Comments on Applicant Response to the NMFS

US Army Corps of Engineers Permit Application Number SAJ-2004-12518

This analysis was performed on behalf of the Coral Bay Community Council and Save Coral Bay Inc., both non-profit corporations.

Prepared by David L Silverman
3-22-2020

OVERLAY – SEA DIVERSIFIED INC. ISOPACH PLOT ON DOCK PLAN PILING LOCATION DETA

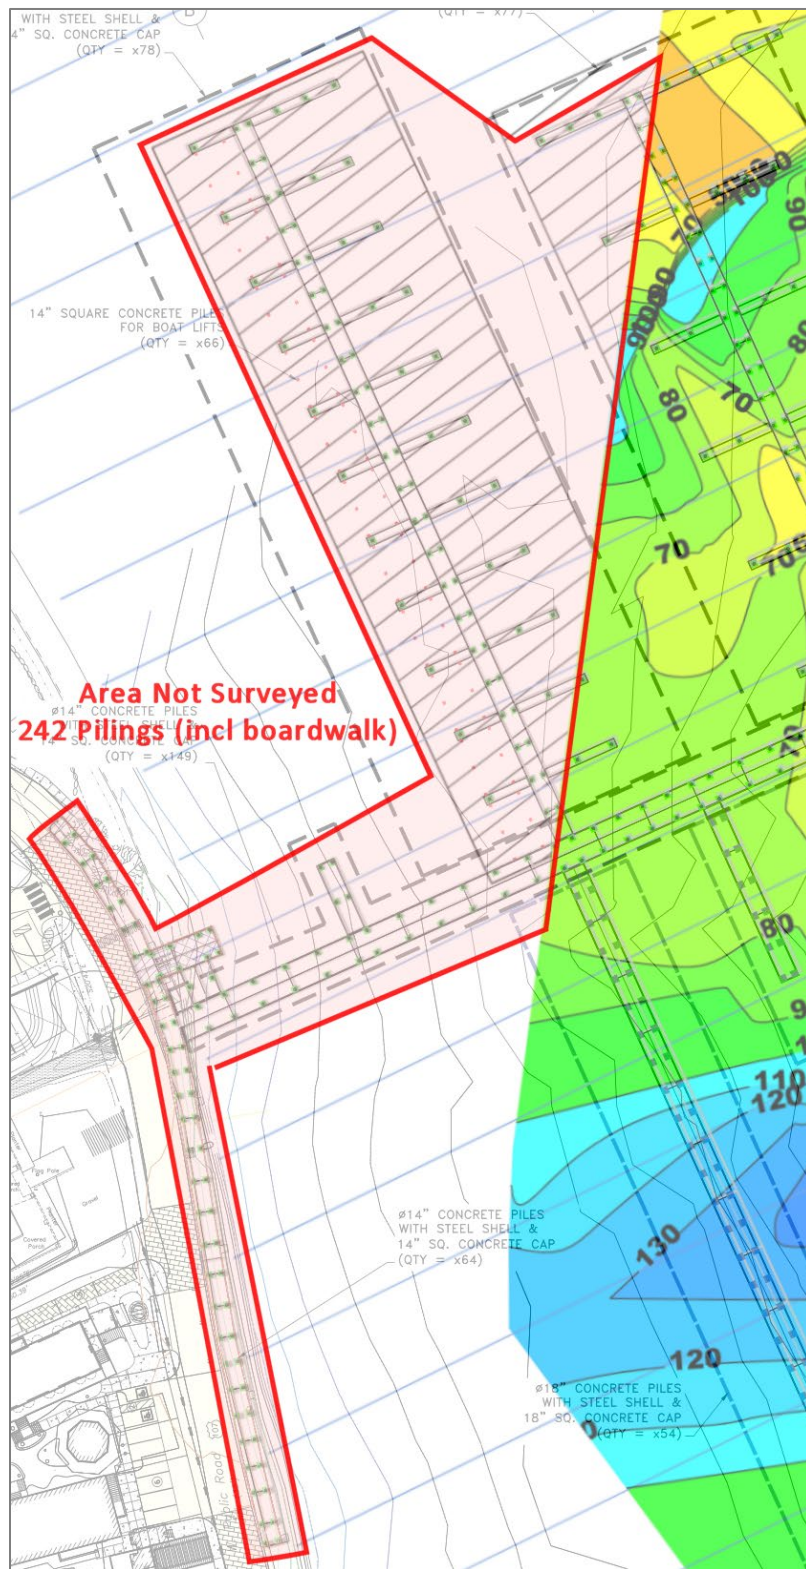
Piling Location	Quantity
Main Pier up to First North Dock	42
First North Dock Main Pier	44
First North Dock Finger Piers	34
Boat Lift Pilings	66
Boardwalk Pilings	56
Total Piling Locations Not Surveyed	242 Pilings

3. The report does not provide any of the underlying digital data to allow an independent analysis of the findings. There appears to be a boundary layer near the surface in the two “typical seismographic clip” illustrations but without the underlying data the significance of the near surface boundary cannot be verified.
4. The findings do not correlate with anecdotal information on the depth to solid rock at many locations throughout Coral Harbor.
5. There are features on the depth chart that seems questionable, including what appears to be a deep “sinkhole” to 130’ depth approximately 200’ from the shore.
6. We request that any future report on seismic findings for depth to bedrock include the entire marina site and include all of the original digital data so the findings and conclusions can be independently verified.
